### DESIGN BRIEF

1195 NEWMARKET STREET  
OTTAWA, ONTARIO  
K1B 1A6

GA PROJECT NO.18630

ISSUED FOR SITE PLAN APPLICATION

4.1 Proposed site plan

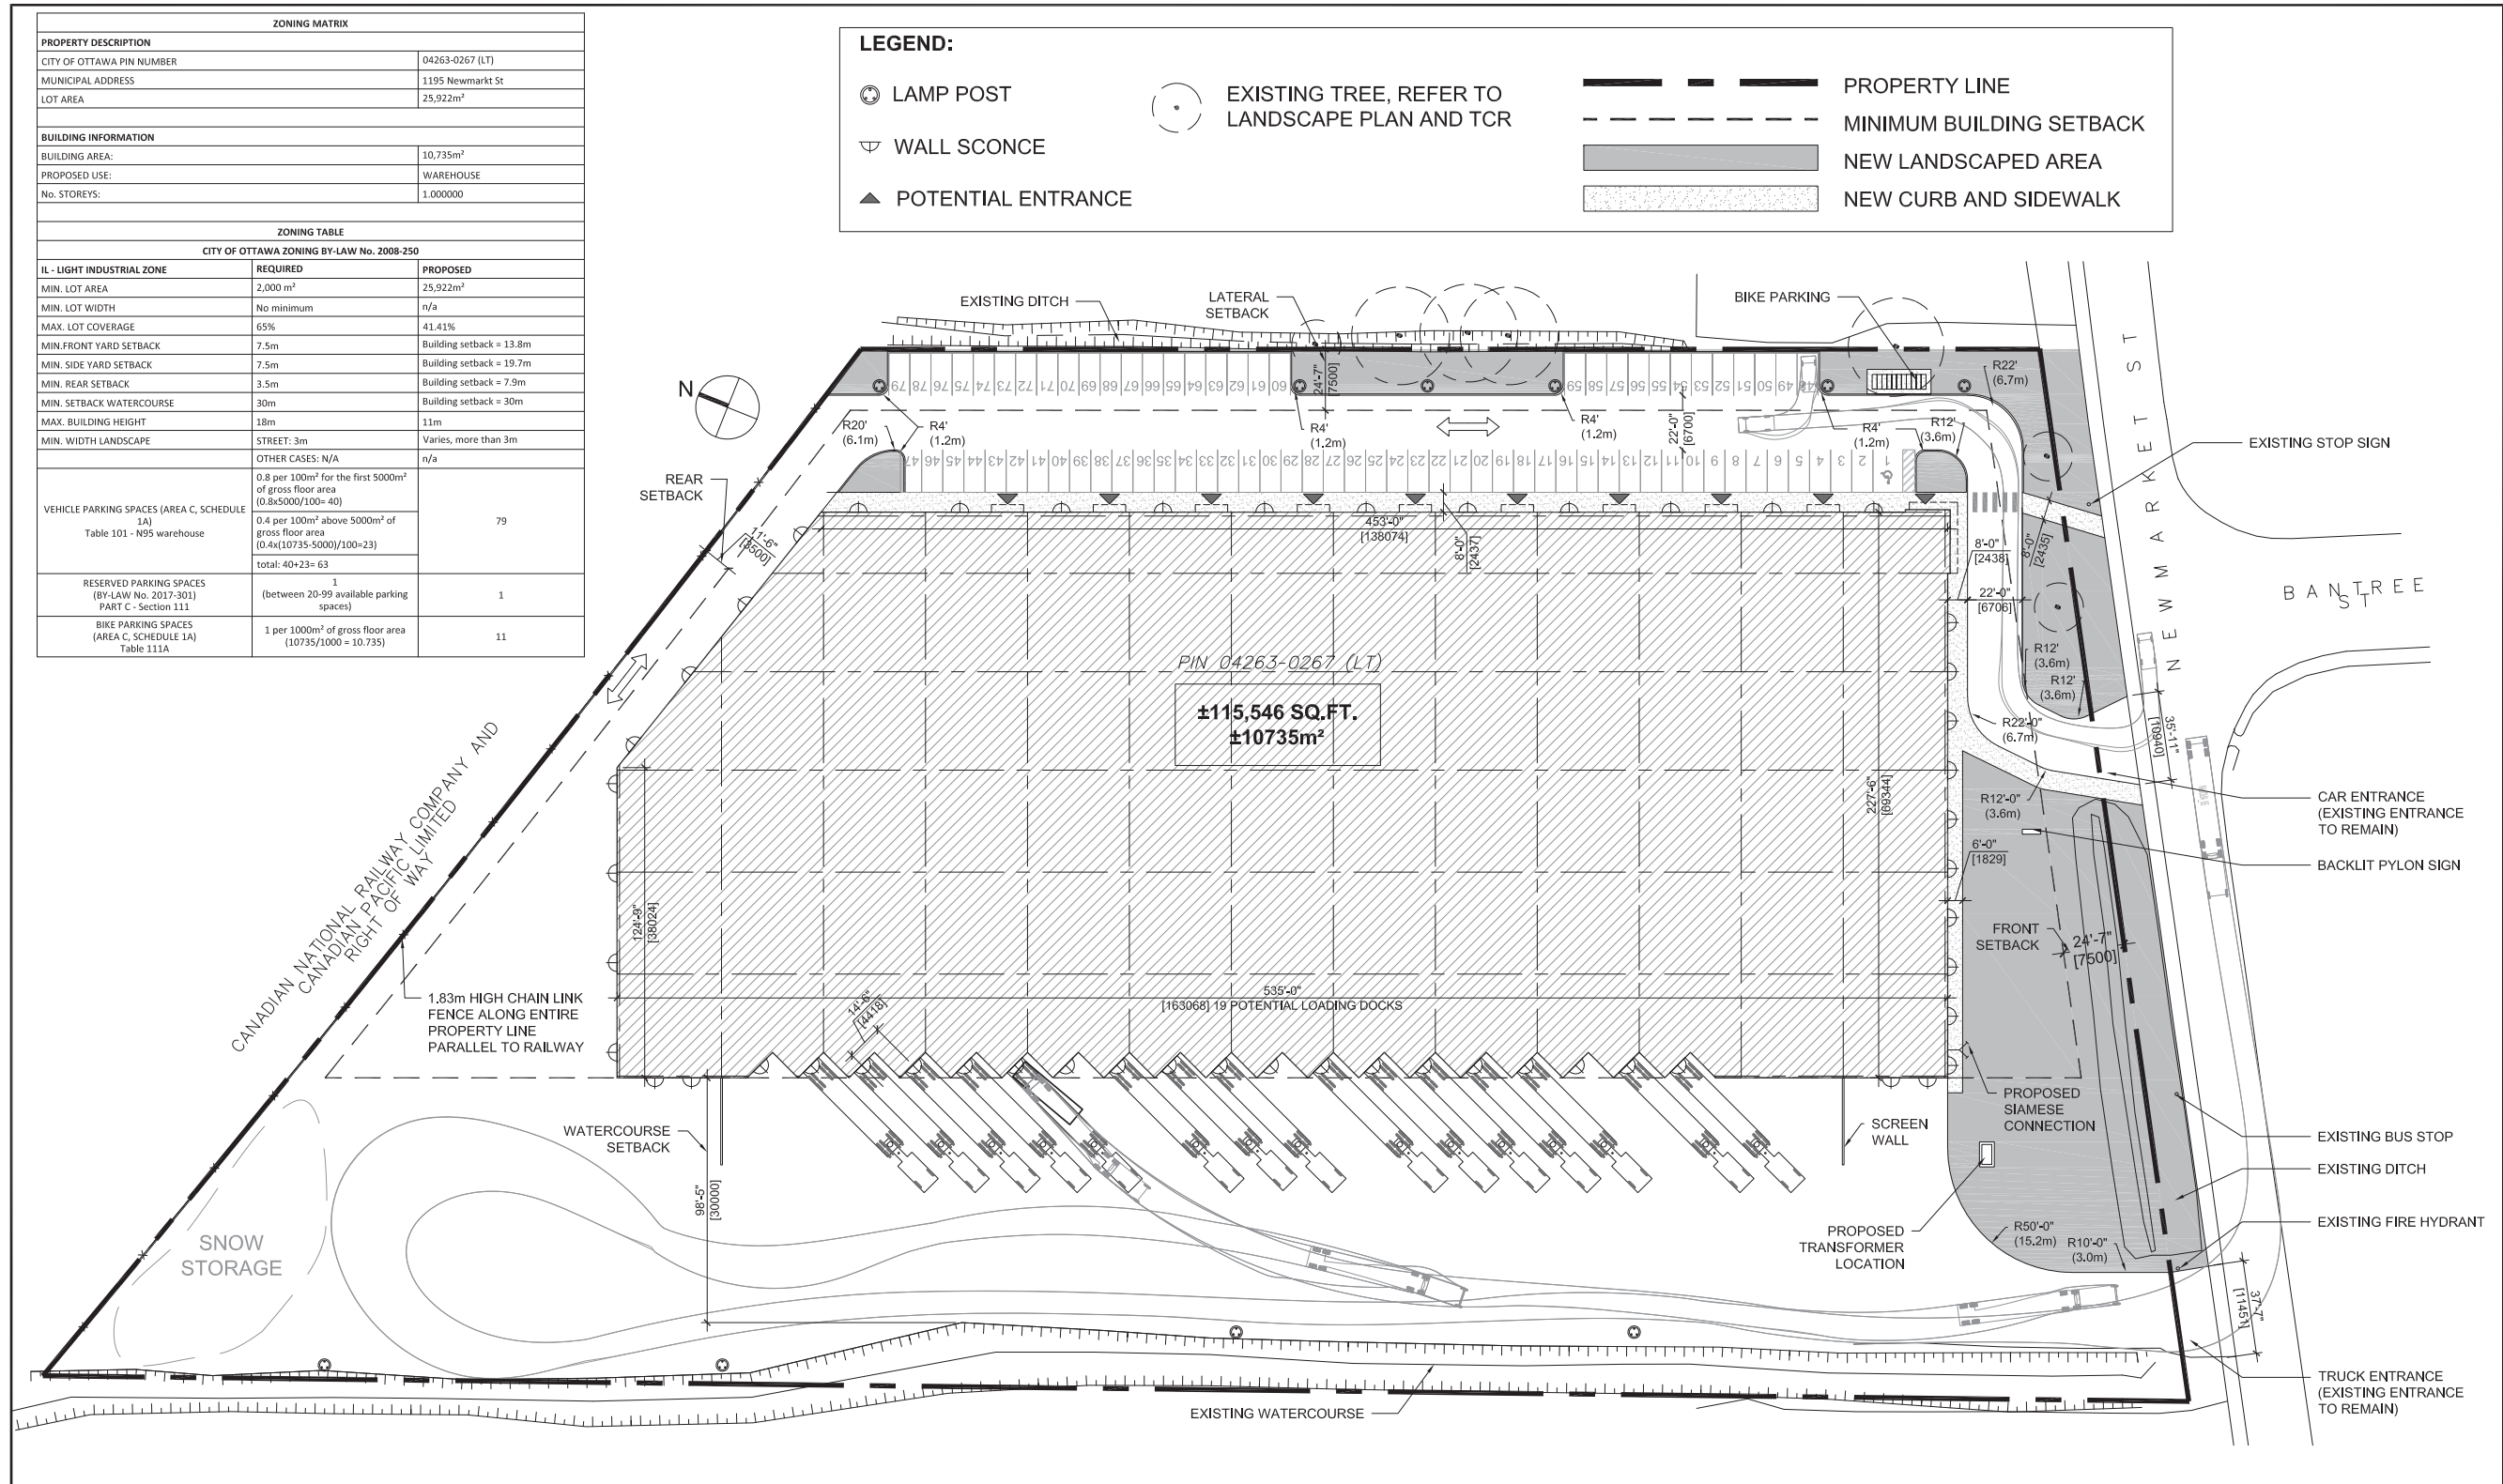
3. The site backs on to a rail corridor: The site backs on to a rail corridor, owned and operated by CP and CN rail. The city's requirements for setbacks on properties backing onto rail corridors are a 30-metre setback from the property line to the face of the building, combined with an earthen berm 2 meters above grade (see page 27 & 38 here). – uses such as landscaping, private roads, landscaping, storage sheds can be located in these areas. Consideration to reducing the setback may be possible, subject to engineered mitigation measures (larger berm, crash wall, etc.) *CN Proximity was contacted and a senior planner by the name of Ashkan Matlabi confirmed that there is no specific minimum setback from a railway right-of-way and a warehouse building. The required rear setback for the city is 3.5m and this is being respected. Refer to email received 2021-05-04 in the Annex.*

3. Landscaping along Newmarket, and VIA rail corridor, and screening of the loading docks from public views are important. Considerations should be given to opportunities for large trees. *A screen wall is planned to block the view of the loading docks from Newmarket. Also see landscape plan for strategies regarding screening.*

2. GeoOttawa maps show that there is a watercourse on the western edge of the property, and our OP requires a 30-metre setback from watercourses. This will need to be addressed with the CA and the city. *The watercourse is indicated on the site plan and the 30m setback is respected.*

4. Turning templates will be required for all accesses showing the largest vehicle to access the site; required for internal movements, at loading areas and at all access (entering and exiting and going in both directions). *Truck and car templates are shown on the site plan.*
